**FINAL
ENVIRONMENTAL IMPACT REPORT**

**DEL PASO REGIONAL PARK MASTER PLAN
IMPLEMENTATION PROGRAM**

**SCH# 84091704
JANUARY 1985**

SUBJECT: Final EIR for the Del Paso Regional Park Master Plan Implementation Program

CITY OF SACRAMENTO
DEPARTMENT OF COMMUNITY SERVICES

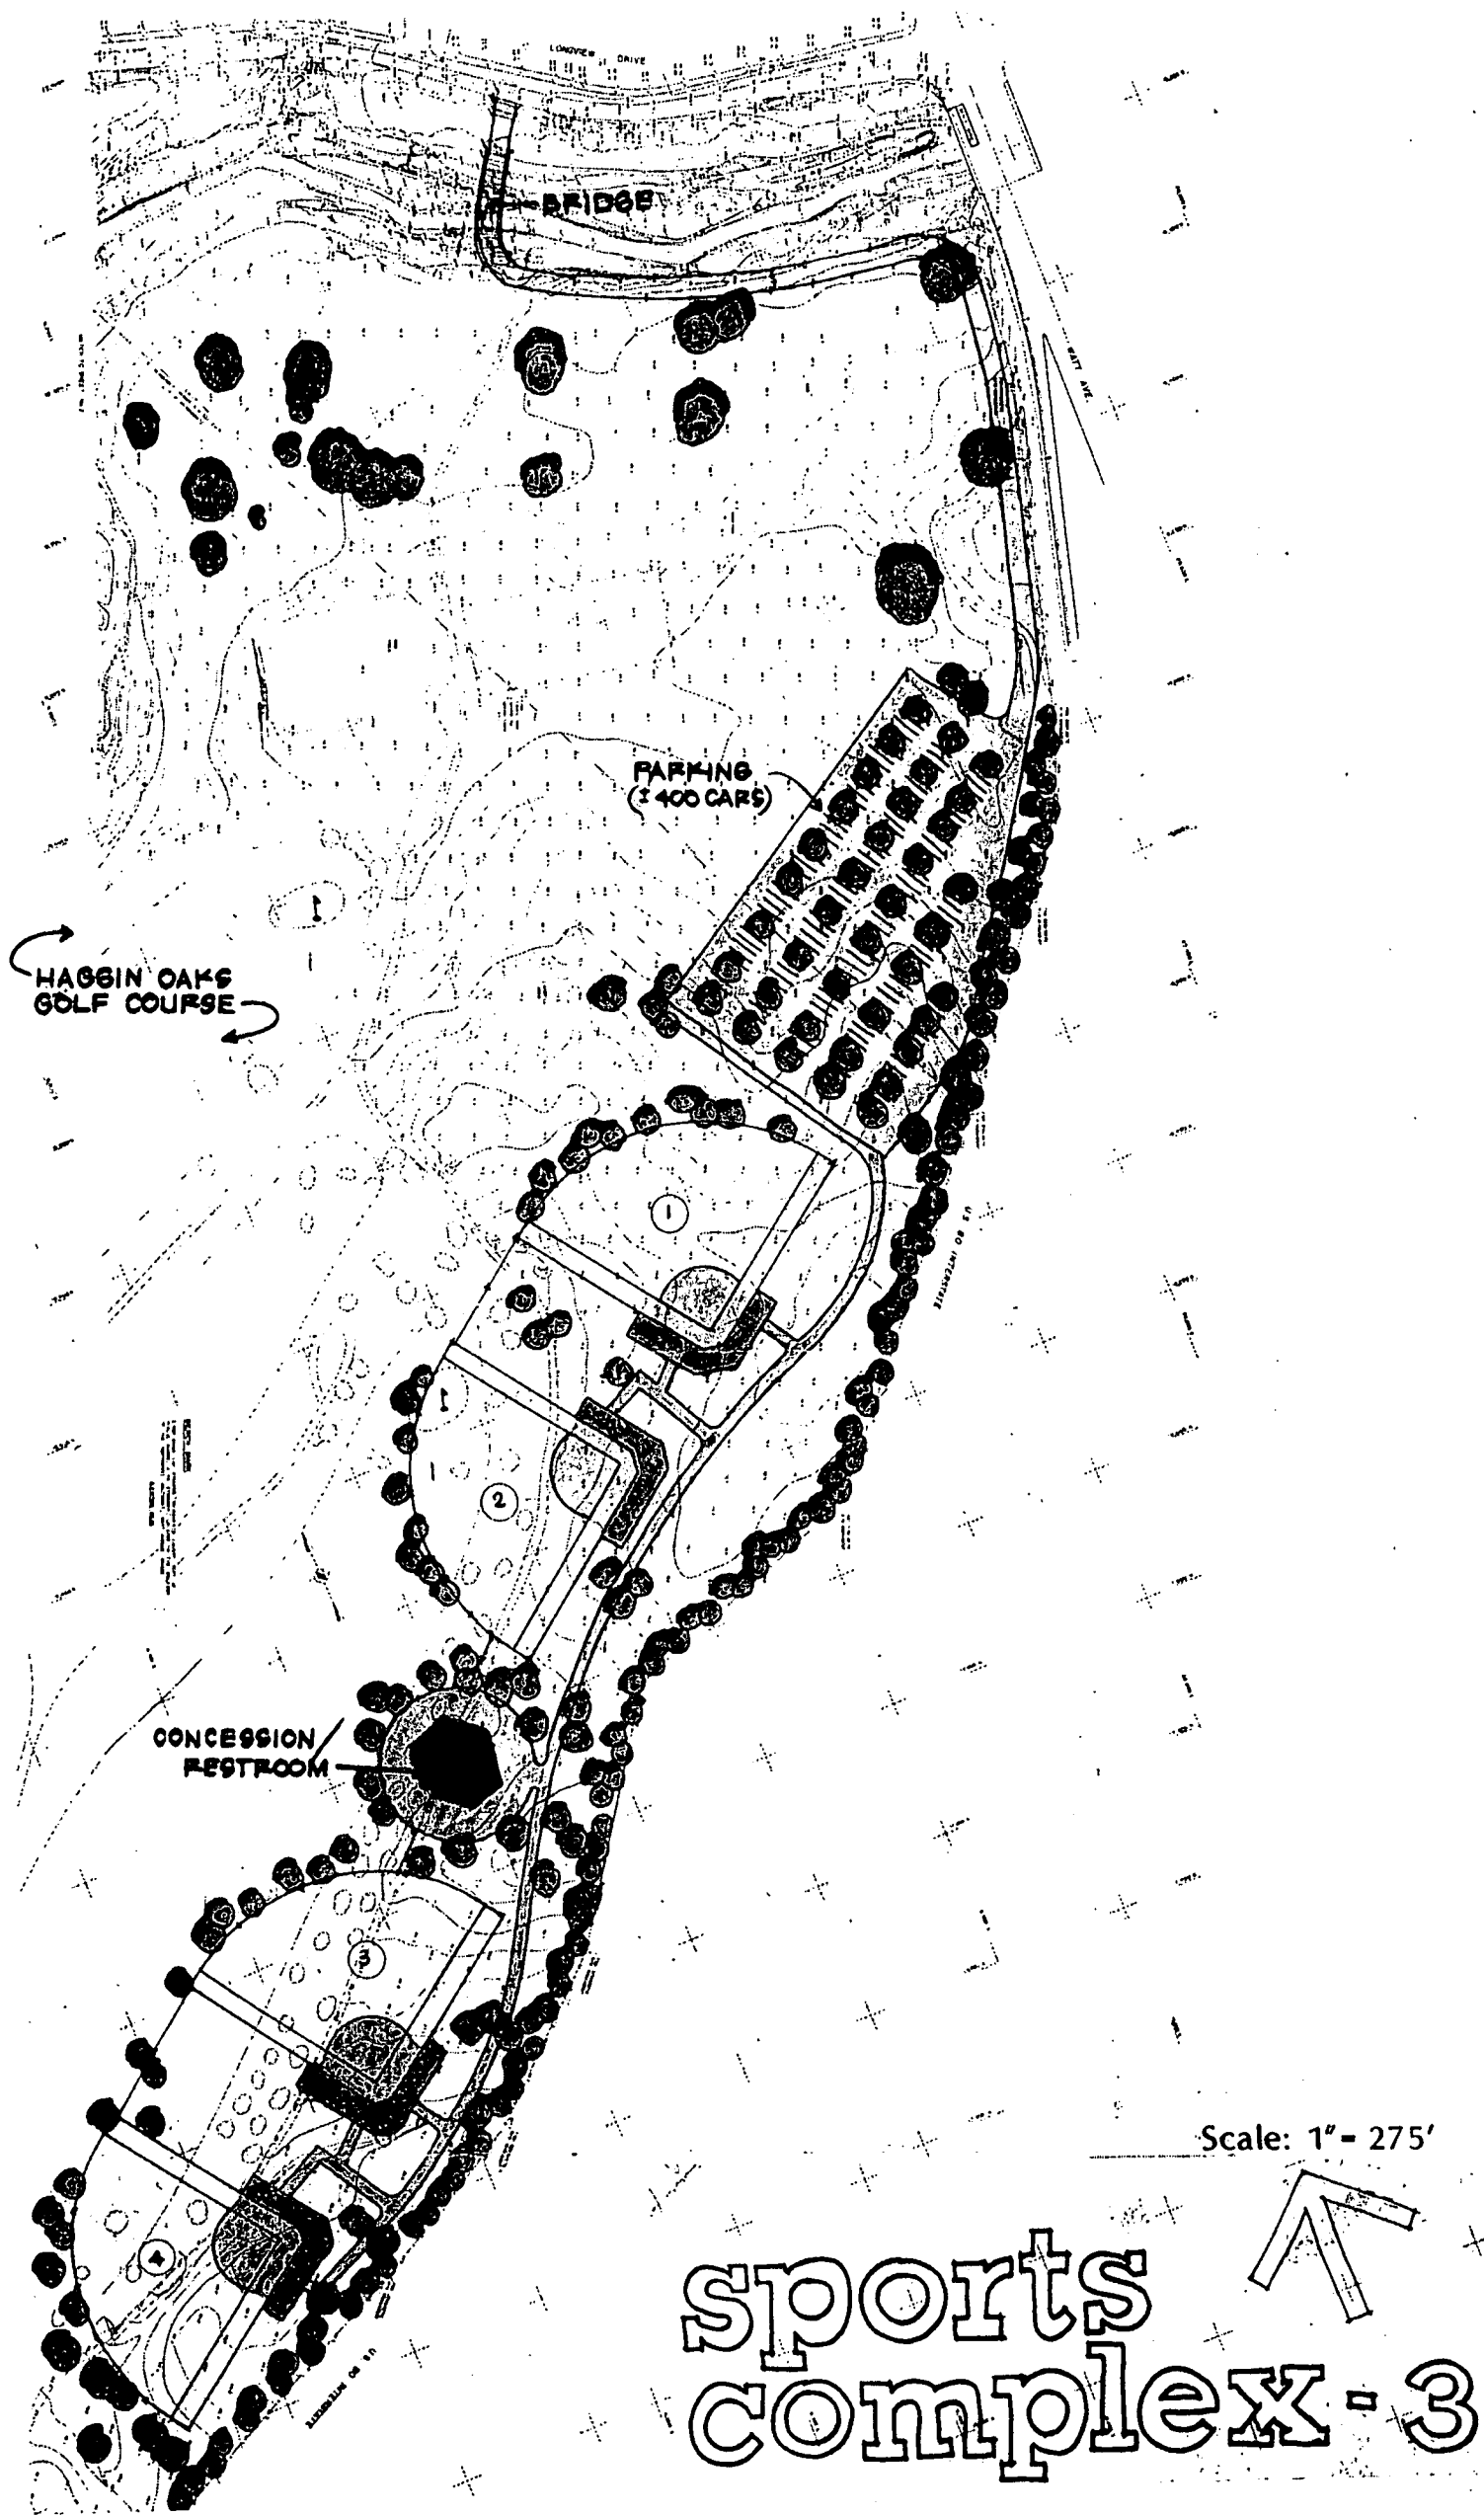
Comment: The City of Sacramento did offer two alternatives to their softball complex but their drawings were so grossly inaccurate and their scale so questionable they could not be analyzed. Possibly as a result of these bad data inputted to Jones and Stokes the Draft EIR is so inadequate in the opinion of ACRP that it cannot be salvaged without a major rewriting.

Comment: Maps of Alts 1, 2 and 3 are presented on pages 10, 11 and 12. These maps are drawn on different scales and with different orientations. In order to compare the impacts of different configurations of the sports complex, parking lot and access route, the final EIR must present maps of the 3 alternatives using the same scale of orientation. Moreover, the maps presented on p. 10-12 are inaccurate. The Final EIR must contain maps based on the land survey conducted by the city and

Response: When the DEIR was prepared, the consultant relied on the only maps that were available. The consultant was aware that these maps were not to scale, but the City felt that a meaningful analysis could nevertheless be performed since potential impacts could be identified without more detailed maps. During the public review period, more detailed maps of the alternatives were prepared (see revised Exhibits B-3, B-4, B-5).

Response: Revised maps of the sports complex alternatives (at the same scale) have been prepared (see revised Exhibits B-3, B-4, and B-5 in Section 2, Key Revisions of this FEIR). In addition, base maps of the park showing existing environmental constraints have been prepared (see Exhibits 2-2 and 2-3).

Comment: EXHIBIT B-4, B-5. These two figures need to be substantially upgraded. EXHIBIT B-4 softball fields should be offset such that the athletic complex is south of the vernal

Comment: Impact, elimination of soccer fields, Sports Complex-2. The soccer field would not have to be eliminated if fairway #13 of Haggin Oaks Golf Course was moved 200 ft into a 400 ft rough area separating it from fairway #14. This could be accomplished even if the softball fields were set further south than is shown in EXHIBIT B-4. (Steve Talley for ACRP)

Response: See response to Comment F-25A. The access road B as shown in revised Exhibit B-4 will avoid the large oaks in the northwestern corner of the terrace, but would probably remove some oaks and other vegetation at the stream crossing.

Comment: EXHIBIT B-5 (Alt. 3) should also receive accurate updates respecting position of the access route (the Nov. 21, 1984 route should be used) and natural habitat features. This plan could be made more environmentally sensitive by moving the parking lot to the south of the fields and running the access route parallel to the Business 80 right of way. Alternatively two 200 car lots could be put at either end. In either case there is sufficient space for overflow parking at the southwest end of the complex. City staff should seriously try to upgrade the quality of this plan as along these guidelines. The only real disadvantage is that space for a soccer field would not be available. (Steve Talley for ACRP)

EXHIBIT 2-3. ENVIRONMENTAL CONSTRAINTS

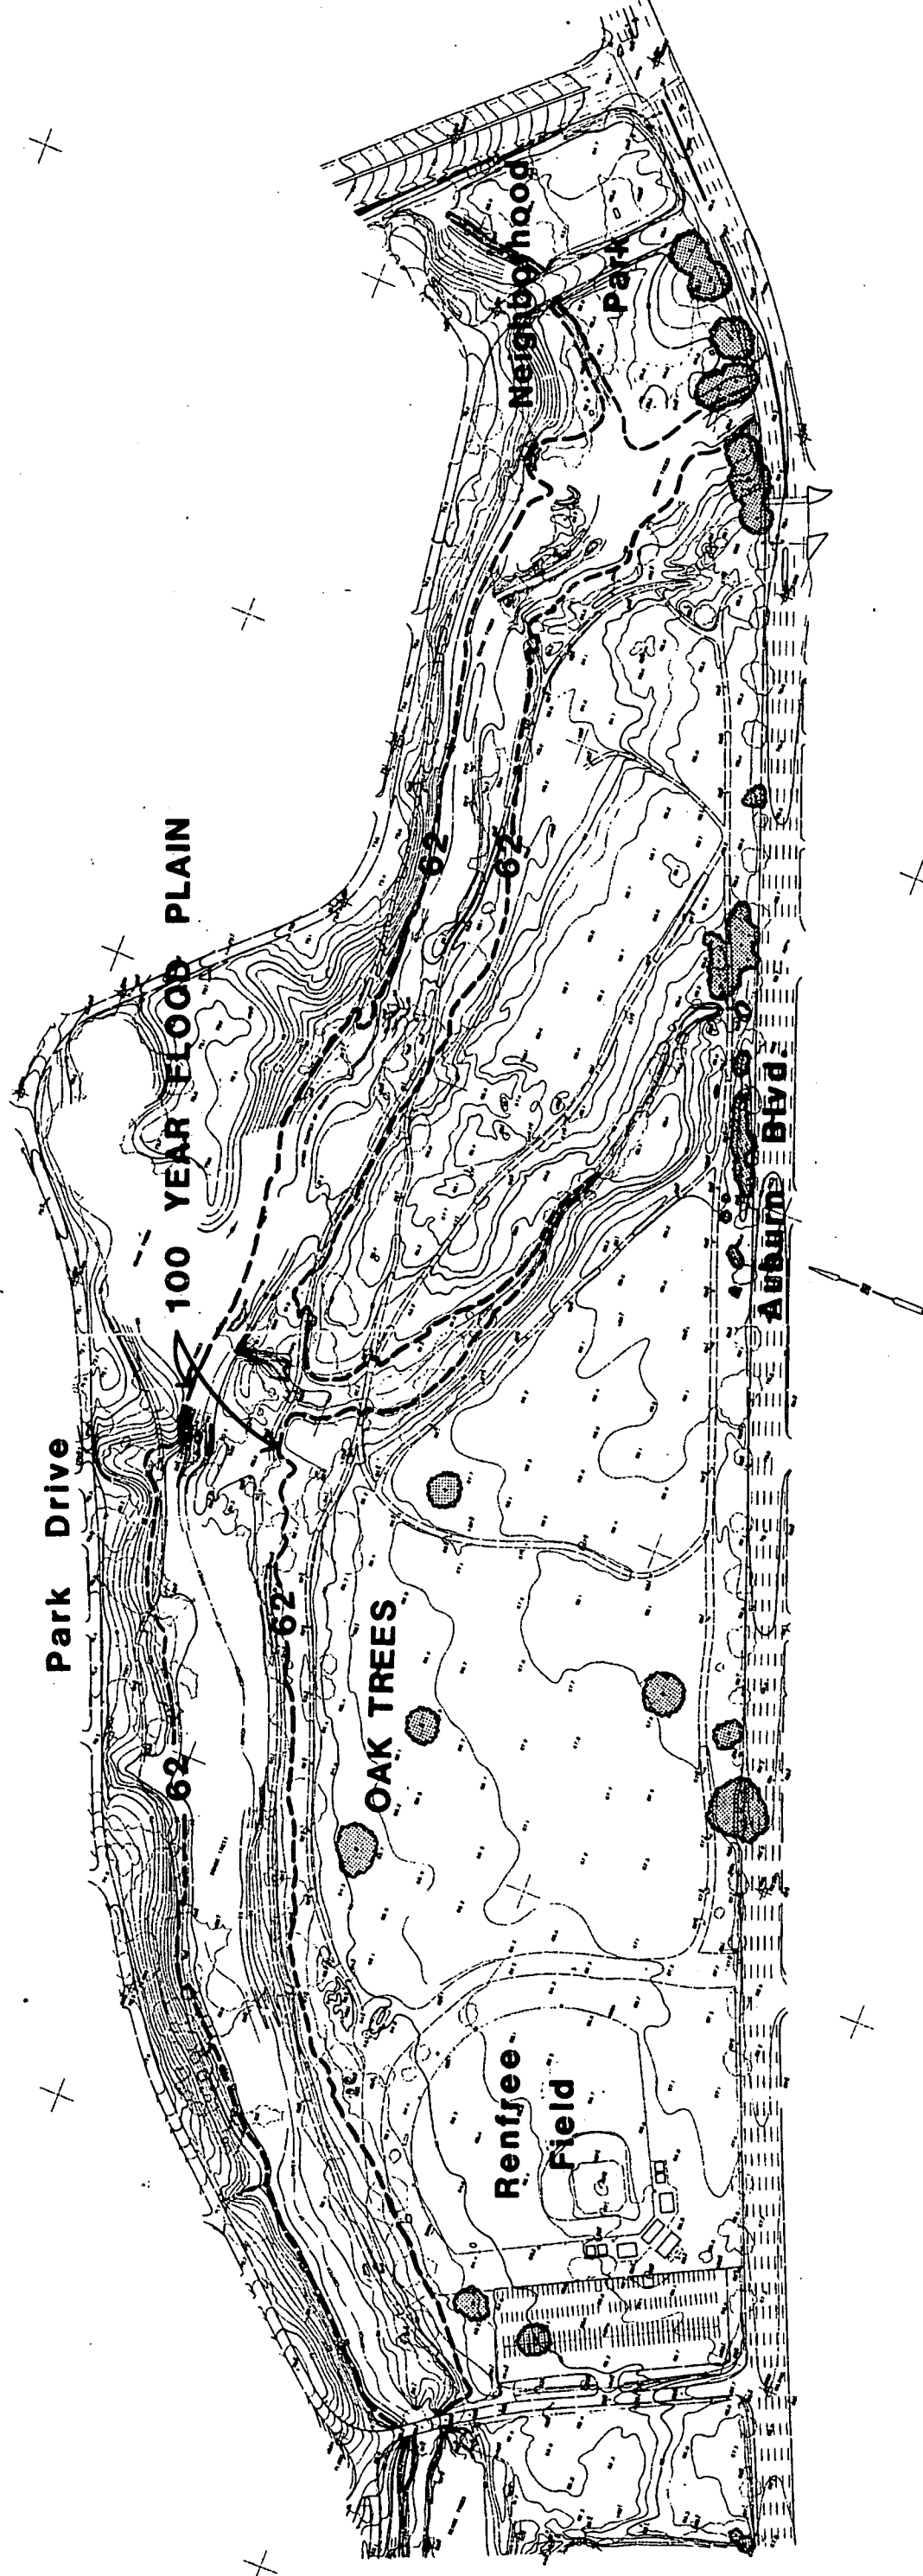
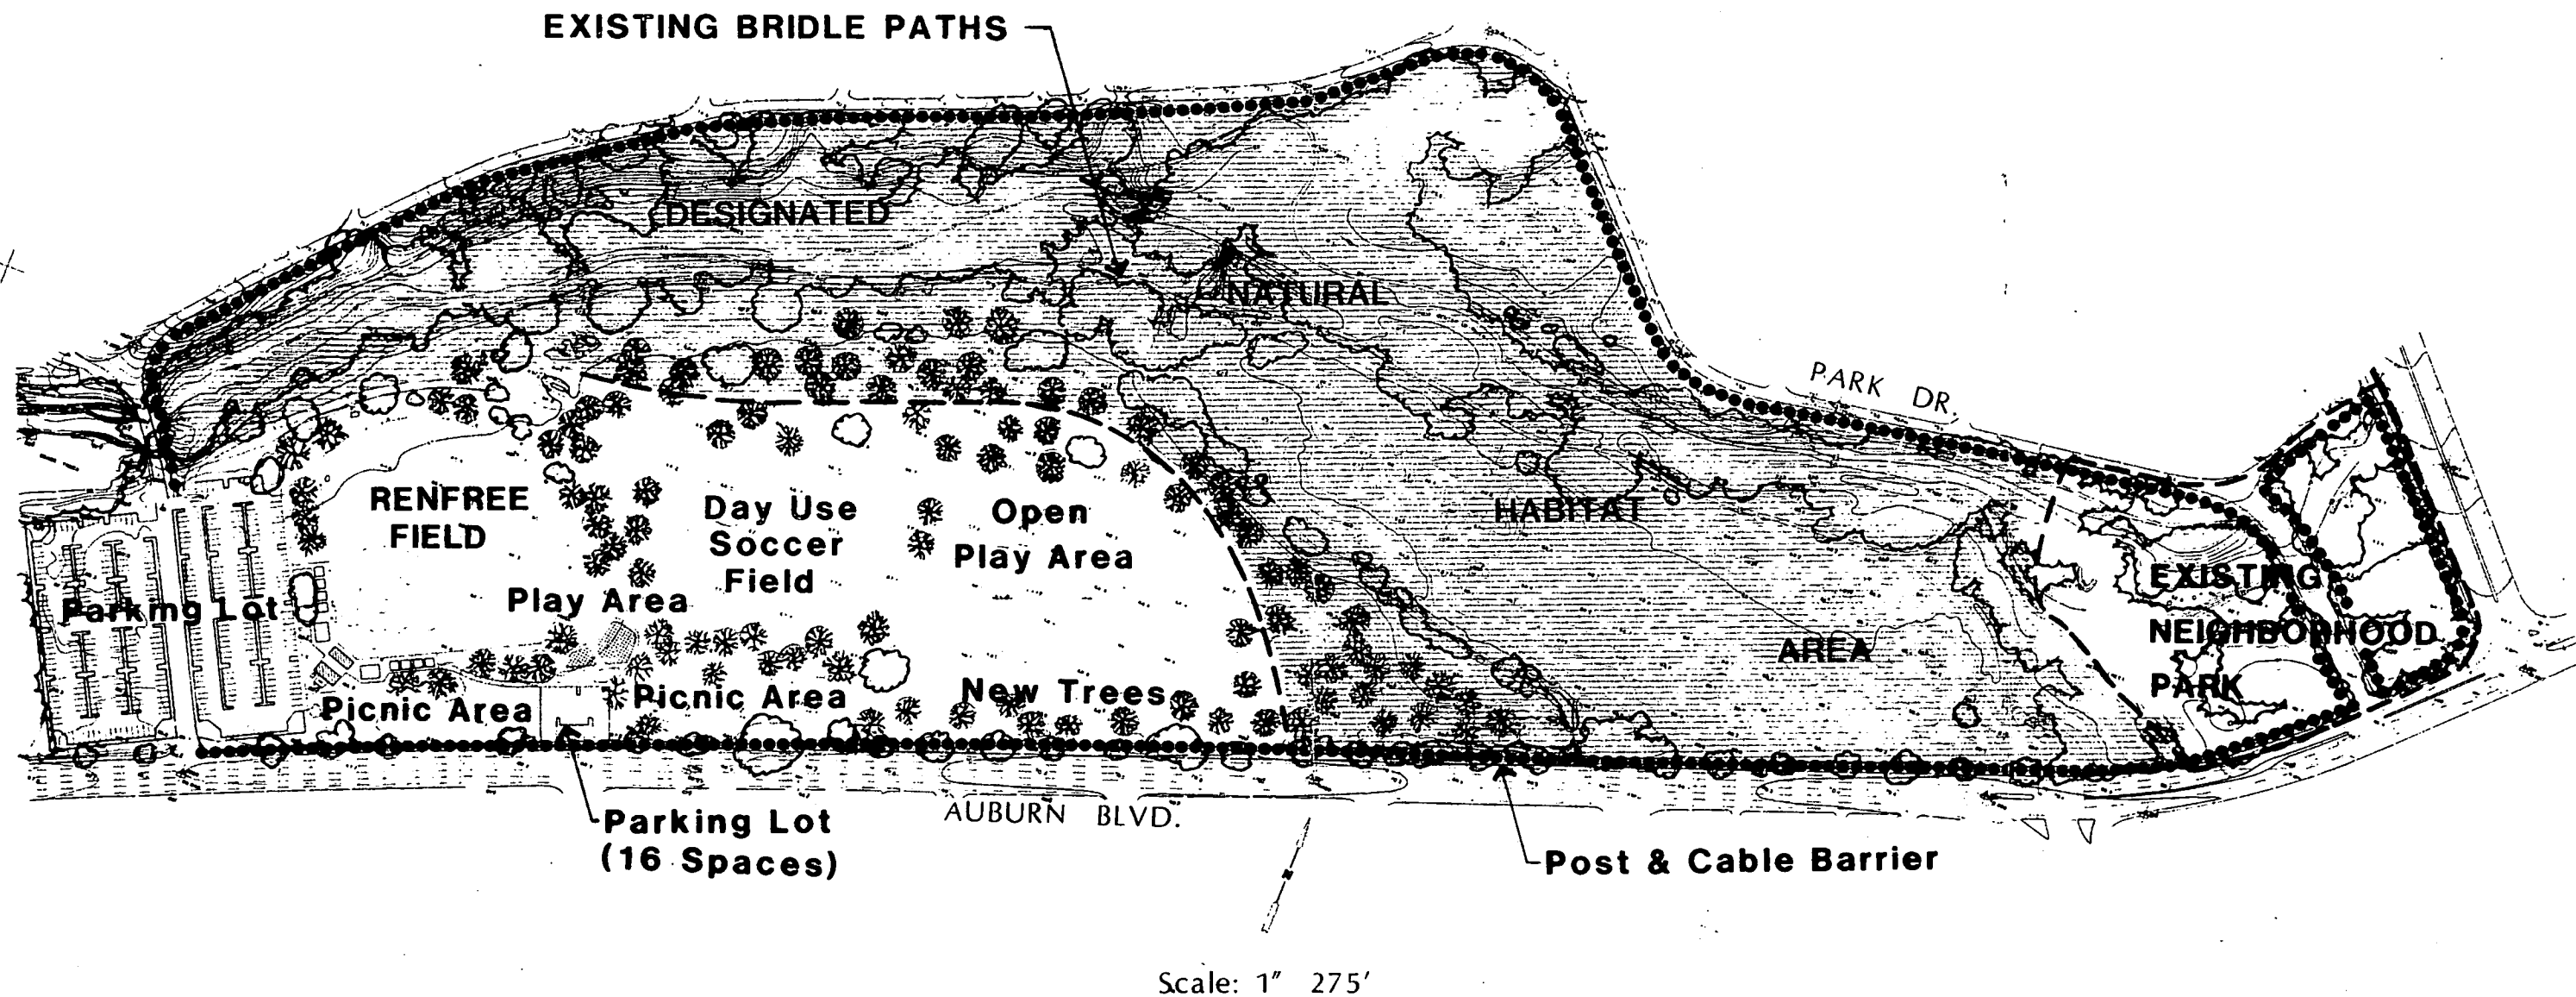
detailed base map which characterizes the open space as it now exists. The EIR presents the regeneration areas on a very small map of the conceptual master plan in Exhibit F-2. This makes the data not only difficult to interpret, but also presupposes the implementation of the entire conceptual plan. Since most of the park's oak regeneration is occurring within the natural open space, there is no need to include a map of the entire golf course. Provide current maps of the undeveloped park areas and then depict regeneration areas. Use Dr. Talley's detailed vegetation maps of the park. A number of these were provided to the city. (Tim Vendlinski for ACRP)

Response: Figures 2-2 and 2-3, in Section 2, Key Revisions of this FEIR, graphically present environmental constraints on topographic maps for the areas being considered for development in the Master Plan Implementation Program.

FIGURE 1

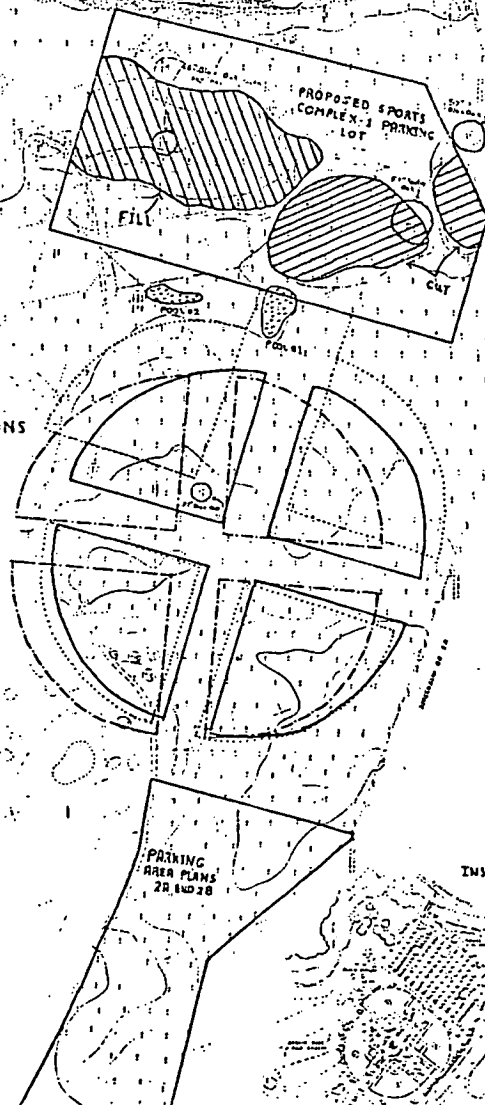
The placement of a parking lot on the north side of the sports complex-1 layout would mean the largest vernal pool would be under about four feet of fill. (Pool #1 is on the mall between the parking lot and athletic complex in this plan.) Even if pool #2 could be saved it would have lost virtually all of its watershed and would be subject to inundation by irrigation water during summer. (Figure 1).

By placing the parking facility on the north side of the athletic complex, soccer players and spectators would have to walk over 1,000 ft to get to the playing field. Without access to the extensive unused lands between Business I-80 and Haggins Oaks Golf Course these lands will not be able to function as public park land (Figure 1, inset). (Steve Talley for ACRP)

The parking lot for sports complex 2A and 2B splits into three drainages which flow onto Haggins Oaks Golf Course. Topographic gradients in the open field south of the athletic complex are modest. The area can probably be graded to an even slope with an approximate one foot cut centered about the 75 ft contour line running southwest of softball field #2. This material would primarily be deposited immediately to the southeast along the Business I-80 right of way. Another smaller cut and fill would be necessary at the extreme southern end of the paved parking area (Figure 1). (Steve Talley for ACRP)
